Value Engineering Study Report

*Projects – STP – 9108(4)(5)
P.I. Nos.. –751770 & 751775*

Widening of Battle Creek Road – Mt. Zion Blvd.

RE: Submittal of the final Value Engineering Report
Projects – STP -9108 (4) (5)
Clayton County
P.I. Nos. – 751770 & 751775
Widening of Battle Creek Road – Mt. Zion Blvd.
PBS&J Project Task Order No. 25

PROJECT:	Georgia Department of Transportation STP-9108(4)(5) – P.I. No. 751770 & 751775 Battle Creek Road – Clayton County	ALTERNATIVE NO.:	ST-3
DESCRIPTION:	USE GUARDRAIL AND PEDESTRIAN RAIL IN-LIEU OF PARAPET	SHEET NO.:	1 of 4

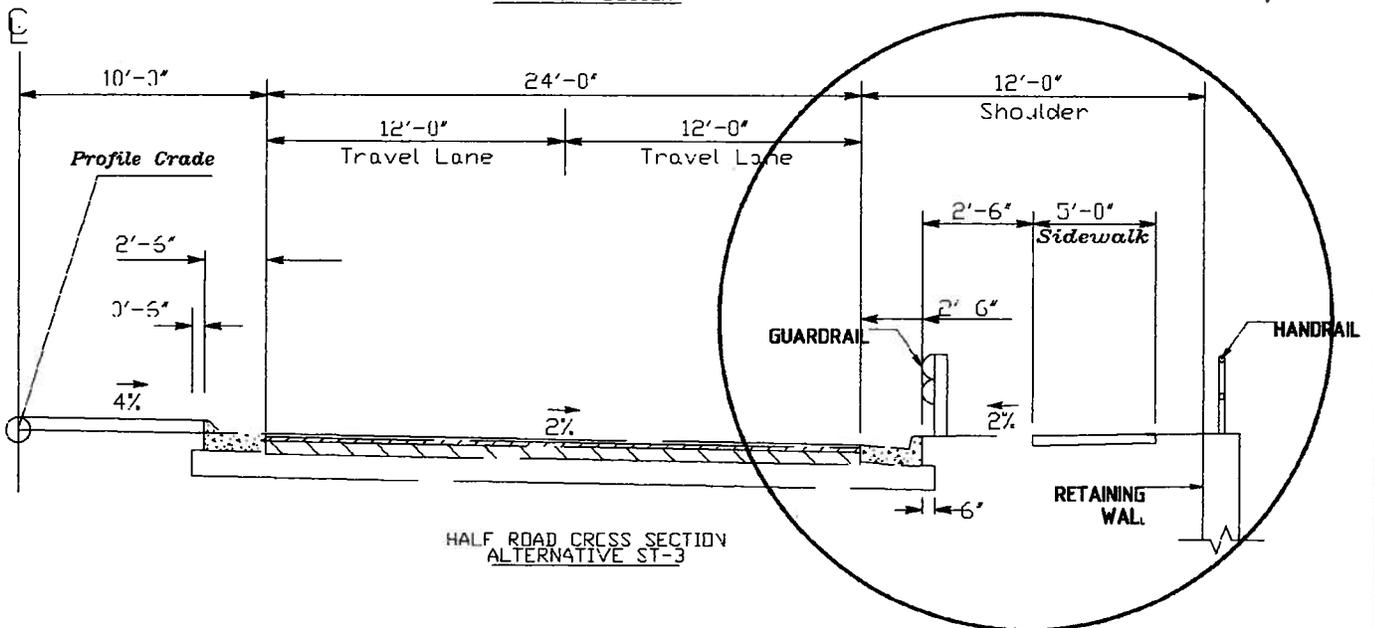
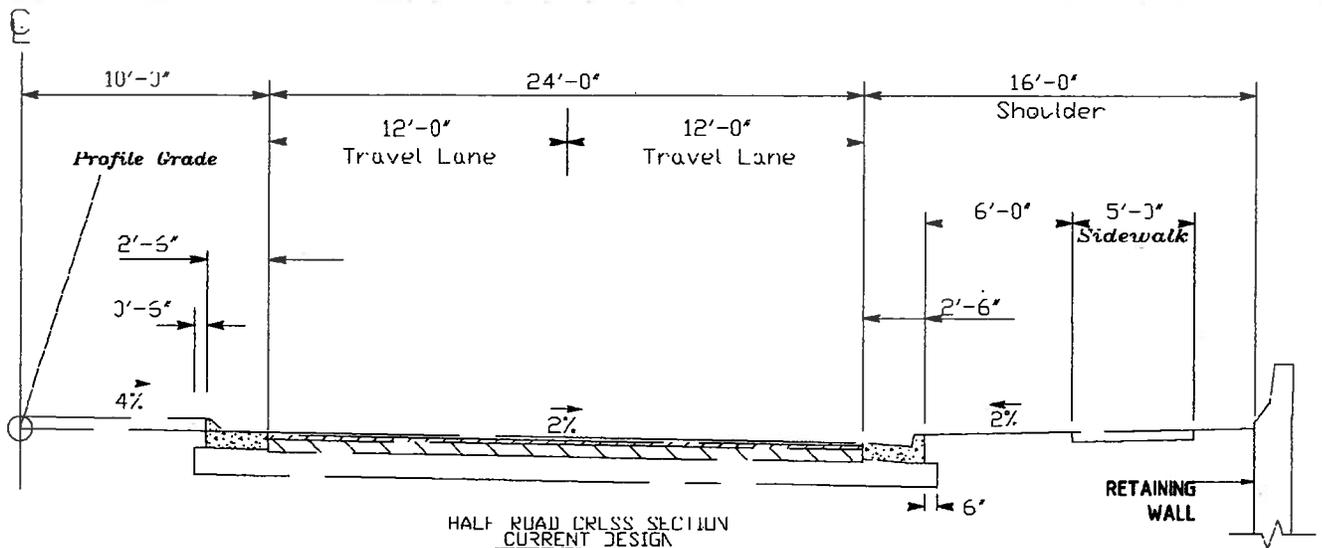
Alternative (Provide Guardrail & Pedestrian rails along length of walls)

ST-4

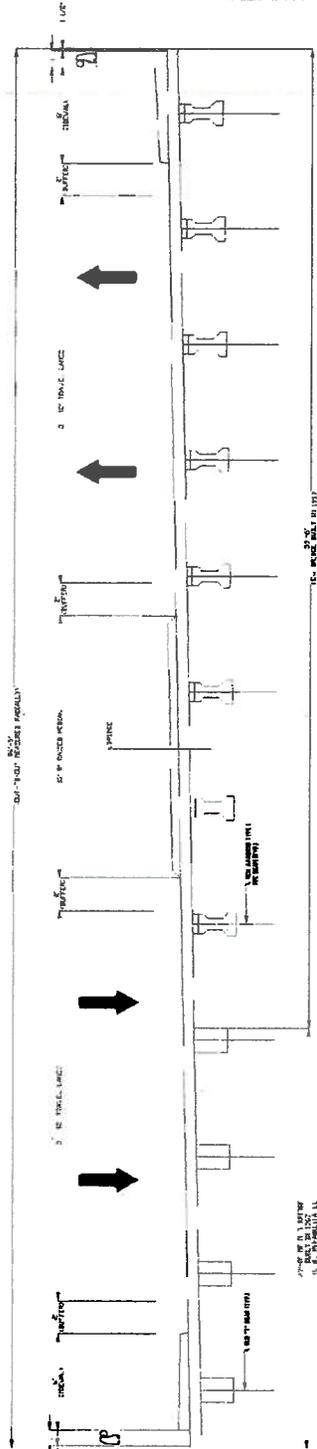
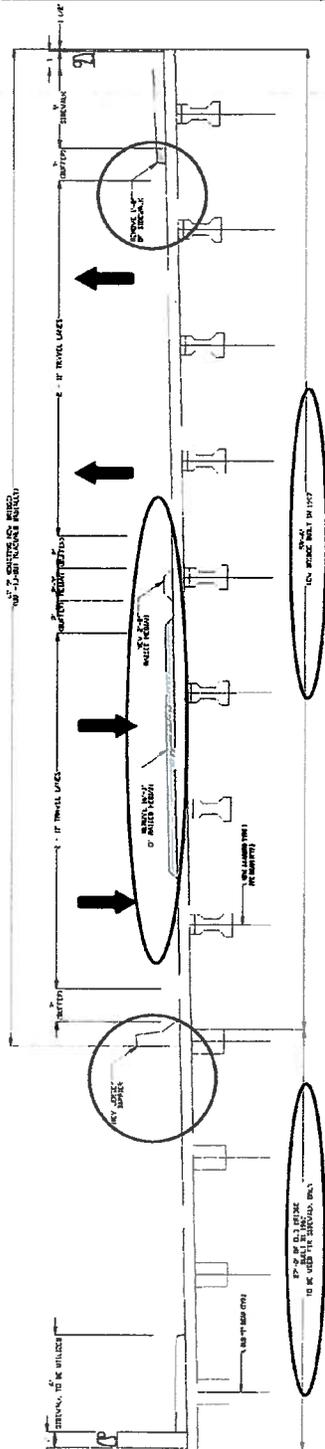
PROJECT:	Georgia Department of Transportation STP-9108(4)(5) – P.I. No. 751770 & 751775 Battle Creek Road – Clayton County	ALTERNATIVE NO.:	ST-4
DESCRIPTION:	RECONFIGURE LANES & SIDEWALK TO UTILIZE NEW BRIDGE ONLY	SHEET NO.:	1 of 4

ST-5

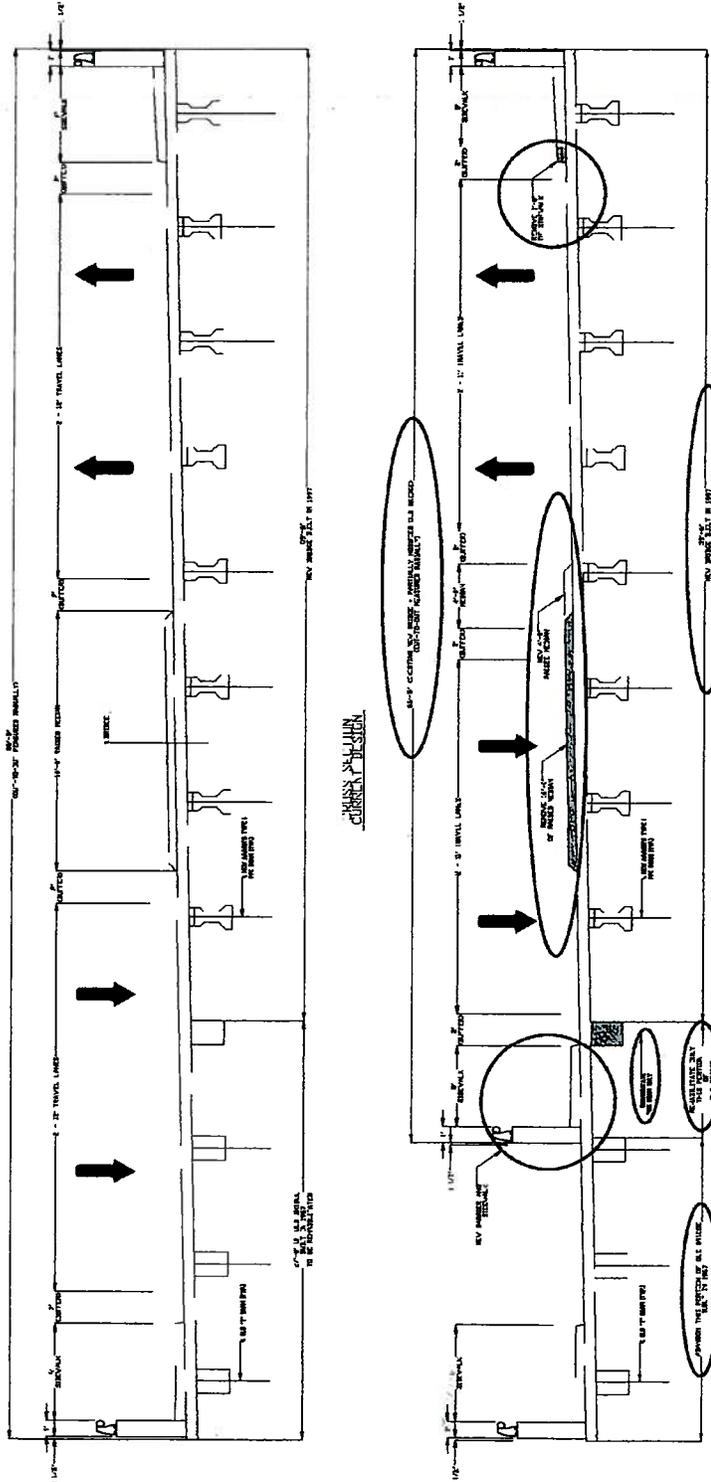
The new bridge is 59’- 4” wide including a 1’-1” parapet, 6’ raised sidewalk and 16’ raised median. By removing the 16’ raised median and 1’ of the raised sidewalk and rehabilitating only the interior beam of the old bridge to carry the dead load from a new barrier and sidewalk (& pedestrian load), the bridge may be able to accommodate a 1’-1” parapet and 5’ raised sidewalk on the south side, 2 – 11’ Eastbound lanes, 2’ buffer, a 4’ raised median, 2’ buffer, 2 -11’ Westbound lanes, 2’ buffer, 5’ raised sidewalk and a 1’-1” barrier on the North side. The out-to-out of the modified superstructure will be 66’-5”. The remaining portion of the old bridge may be abandoned.

ROW-4

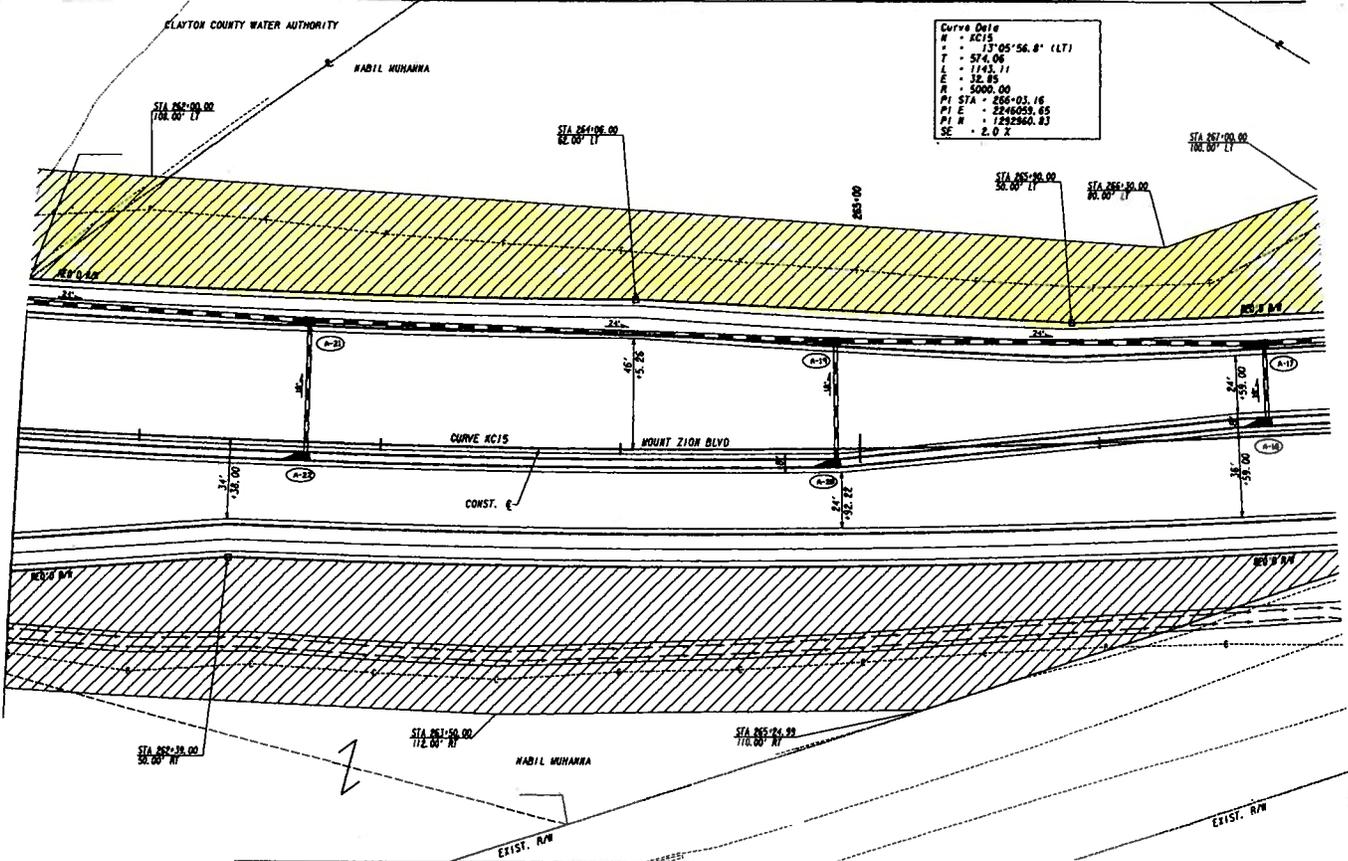
PROJECT:	Georgia Department of Transportation STP-9108(4)(5) – P.I. No. 751770 & 751775 Battle Creek Road – Clayton County	ALTERNATIVE NO.:	ROW-4
DESCRIPTION:	LIMIT R.O.W. TAKING AND EASE CONSTRUCTION BY SEGREGATING WIDENING TO ONE SIDE.	SHEET NO.:	1 of 4
